UNITED STATES PATENT AND TRADEMARK OFFICE

Office Action Summary

10/566,260

UEBELHART, BAUDOUIN
ERNEST

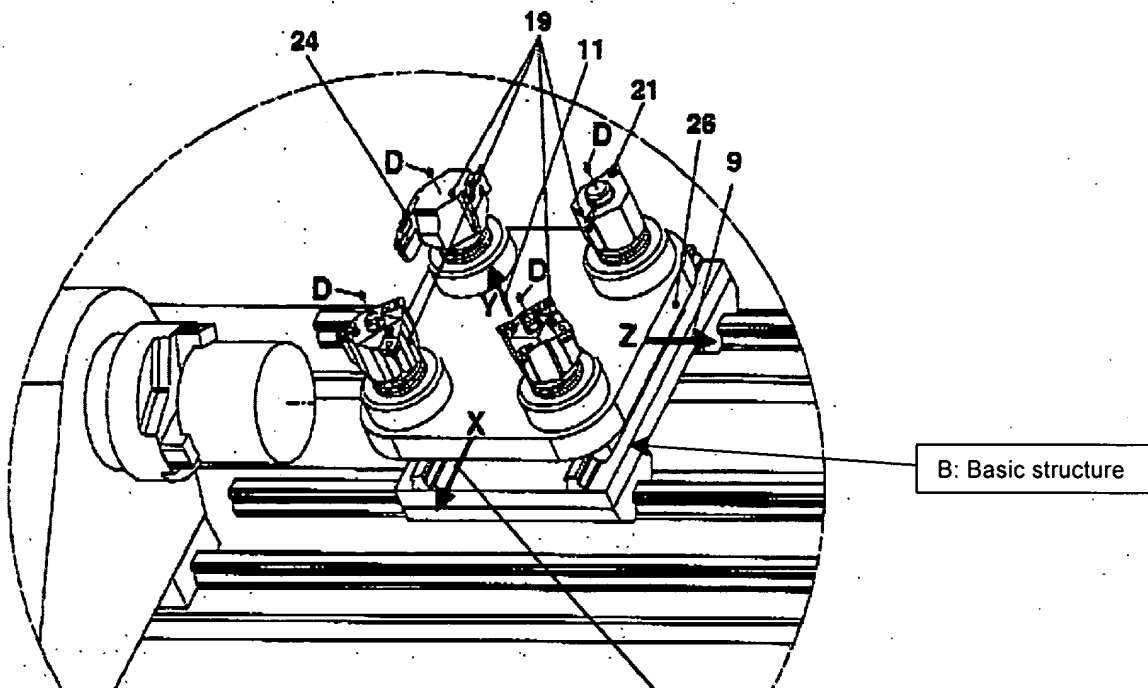
U.S.C. 102(b) as being anticipated by Maier (US Pub. No. 2002/0170396).

Regarding claim 1, MAIER teaches a tool support provided for machining a work piece having a spindle (4) with axis (3), a basic structure (B: see figure below), a slide (26) mounted on said basic structure which is displaceable (X-

axis) in a controlled manner transversely to the spindle axis, two tool holders (19) mounted parallel to each other on said slide for holding different tools ('396, figure 6). Furthermore, MAIER teaches, each tool holder (19) can be brought into use individually (i.e. tool holders are displaced selectively into and out of the working position) ('396, page 4, paragraph 47). Note: it is old and well known that drive means are used for moving items in a machining environment, in this case the slide and the tool holders move simultaneously along axis X). Furthermore, regarding claims 2 and 3, MAIER teaches, said basic structure being mounted on a tool slide which is displaceable along an axis (Z-axis), which is in the same parallel to the spindle axis (i.e. along the spindle axis) ('396, figure 6).
